STAFF REPORT  
(Preliminary Plat)

CASE NUMBER: S/D 99-79 -- NORTHRIDGE HEIGHTS ADDITION

STAFF REPORT  
(Final Plat, Preliminary Plat Approved 12/2/99)

CASE NUMBER: S/D 99-79 -- NORTHRIDGE HEIGHTS ADDITION

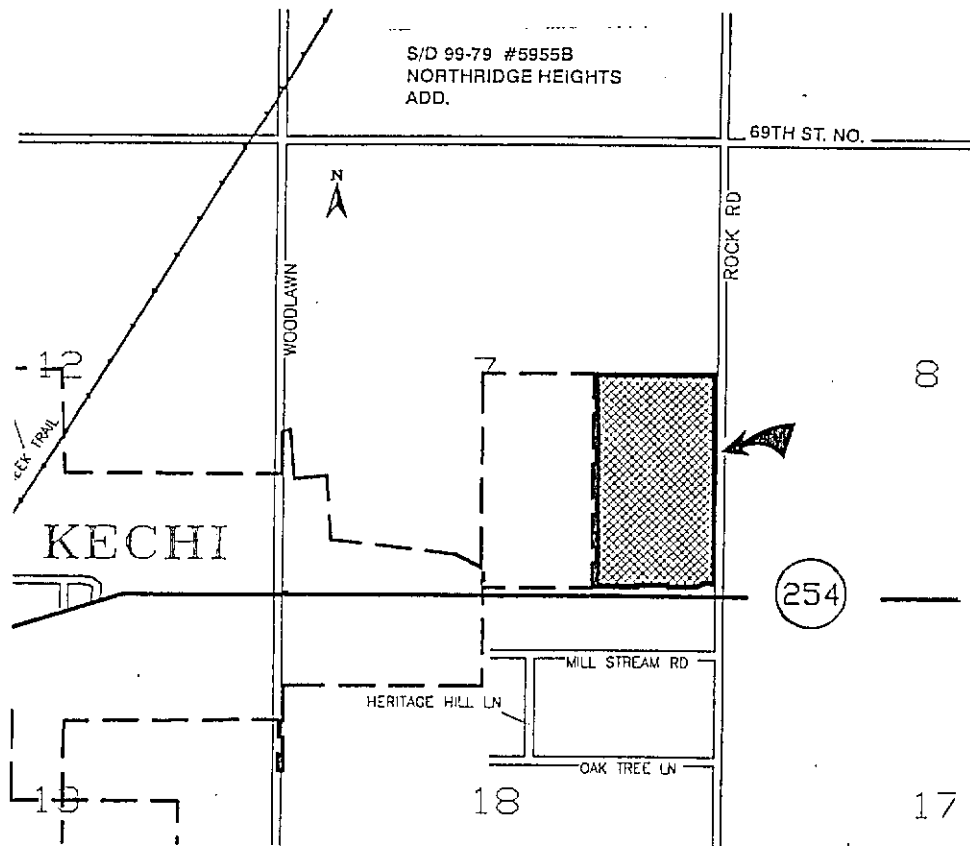
- D. County Engineering needs to comment on the status of the applicant's drainage concept. *The floodplain should be denoted within Lots 8, 9, 10, 13, and 14. A flood study is required including a HEC-2 run.*

- E. Complete access control should be dedicated along the site's frontage to Rock Road and along K-254 Highway. Complete access control should be dedicated for Lot 1 along the easterly 200 feet of the frontage road. The access controls shall be referenced in the plat's text on the final plat.

- K. A contingent dedication of right-of-way should be platted for Chippewa extending to the west line of the plat to provide potential street connection to the adjoining unplatted property.

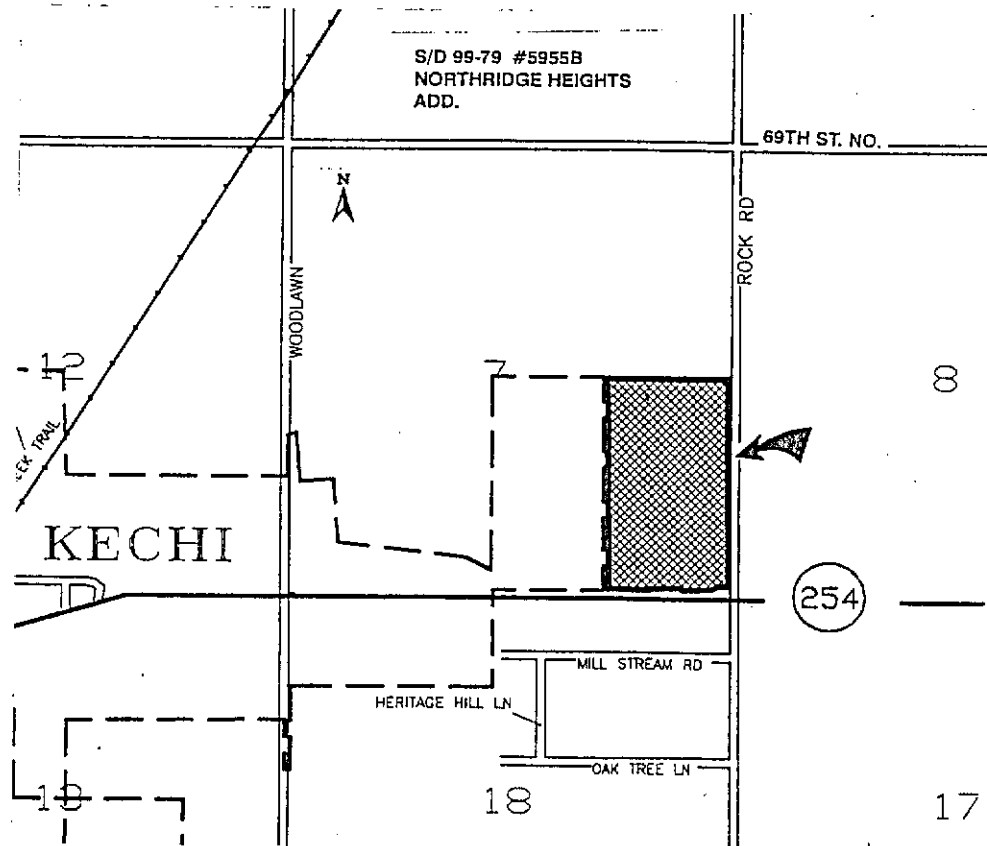
- D. **County Engineering** needs to comment on the status of the applicant's drainage concept. The boundaries of the Floodway Reserves need to be revised. Drainage easements located at the northwest corner of Lot 2, Block A, and in Lots 7,8,9,10, Block A need to be denoted as Floodway Reserve easements. Minimum building pad should be referenced in the plattor's text. The location and elevation of benchmarks are required.

- E. The MAPC certification shall be revised to reference "Northridge Heights".
- F. **County Engineering** should comment on the access controls. Complete access control has been dedicated along the site's frontage to K-254. One opening has been platted along Rock Road.

- I. **County Fire** needs to comment on the acceptability of the proposed street names. The street names are acceptable.
- J. A contingent dedication of right-of-way should be platted for Chippewa extending to the west line of the plat to provide potential street connection to the adjoining unplatted property.

As requested, the right-of-way dedication has been platted.
- K. The plattor's text shall include language that a drainage plan has been developed for the plat and that all drainage easements, rights-of-way, or reserves shall remain at established grades or as modified with the approval of the applicable City or County Engineer, and unobstructed to allow for the conveyance of stormwater.
